SUBDIVISION COMMITTEE
METROPOLITAN AREA PLANNING COMMISSION
STAFF REPORT

AGENDA ITEM NO. 7
MARCH 15, 2001

(One-Step Final Plat)

CASE NUMBER: SUB 2001-28 -- FLAT CREEK ADDITION

VICINITY MAP

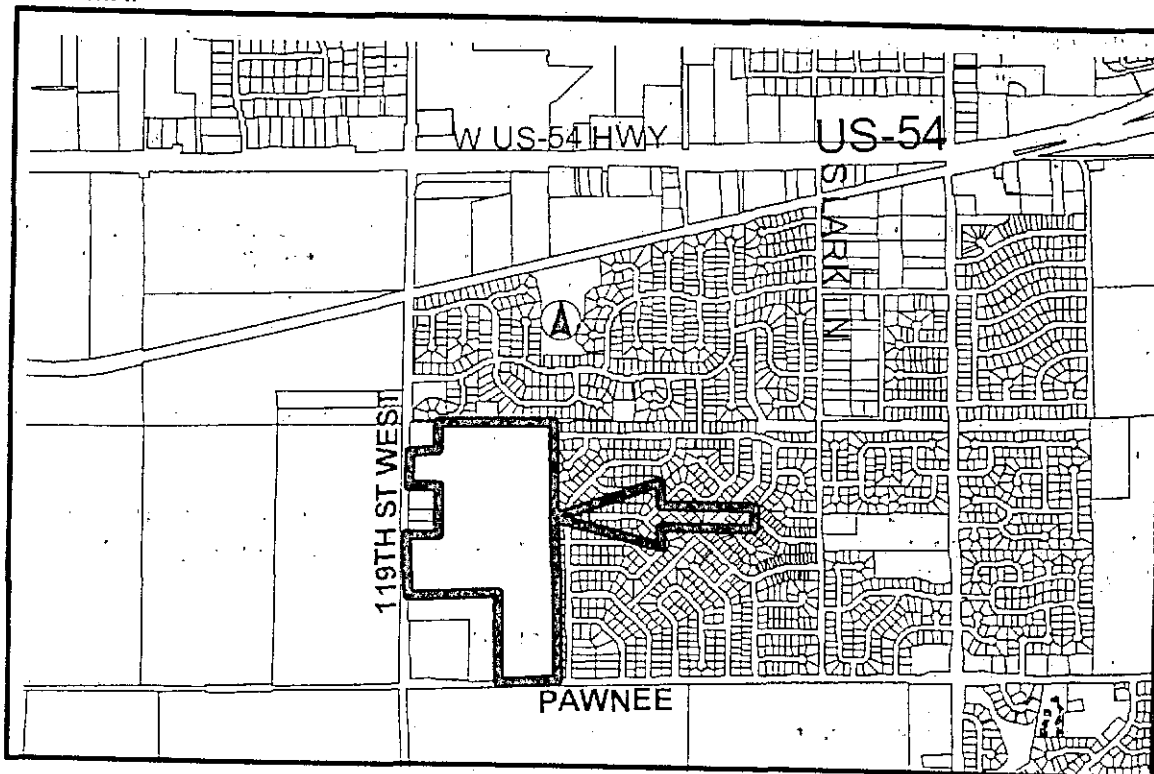
Note: This site is located in the County adjoining Wichita's city limits and a request for annexation shall be submitted. The site is currently zoned SF-20, Single-Family residential and will be converted to SF-6, Single-Family Residential upon annexation.
